Access Compliance Report

Public Rights-of-Way

(Curb Ramps)

Intersection ID: 3770	Main Street: LEXINGTON_APPROACH_DR	Cross Street: TAVERNAY_PY	Location:	N
ADA ID: 21839425C387	Ramp Type: Perp	Initial Pass/Fail: Fail	Overall Compliance: No	Severity Score: 25
Codes/Mitigation Info/Possible Solution		Field Measurements/Component Compliance

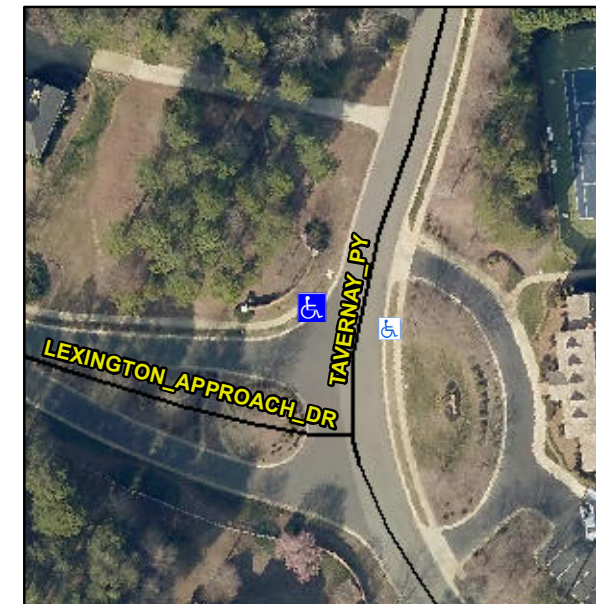
Not Found, R304.2.2

Compliance	Description	Data	Compliance	Description	Data
N/A	Ramp Length (in)	49.0	No	Ramp Slope (%)	13.8
Yes	Ramp Width (in)	48.0	Yes	Ramp XSlope (%)	0.5
N/A	Flare Type LT	N/A	N/A	Flare Type RT	N/A
N/A	Flare Slope LT (%)	N/A	N/A	Flare Slope RT (%)	N/A
N/A	Flare Traversable LT?	N/A	N/A	Flare Traversable RT?	N/A
N/A	Landing Length (in)	N/A	N/A	DWS Provided?	N/A
N/A	Landing Width (in)	N/A	N/A	DWS Contrast?	N/A
N/A	Landing Slope (%)	N/A	N/A	DWS Length (in)	N/A
N/A	Landing X Slope (%)	N/A	N/A	DWS Full Width?	N/A
N/A	Landing Curb? (Y/N)	N/A	N/A	DWS Offset (in)	N/A
N/A	Shared Landing?	N/A			
N/A	Gutter Ponding?	N/A	N/A	Gutter Slope (%)	N/A
N/A	Gutter Lip Ht (in)	N/A	N/A	Gutter X Slope (%)	N/A
N/A	Painted X Walk1?	No	N/A	Painted X Walk2?	N/A
	X Walk 1 Direction	To SE		X Walk 2 Direction	N/A
N/A	X Walk 1 Width (in)	N/A	N/A	X Walk 2 Width (in)	N/A
	X Walk 1 Slope (%)	0.8		X Walk 2 Slope (%)	N/A
	X Walk 1 X Slope (%)	8.2		X Walk 2 X Slope (%)	N/A

Remove & Replace Entire Ramp.
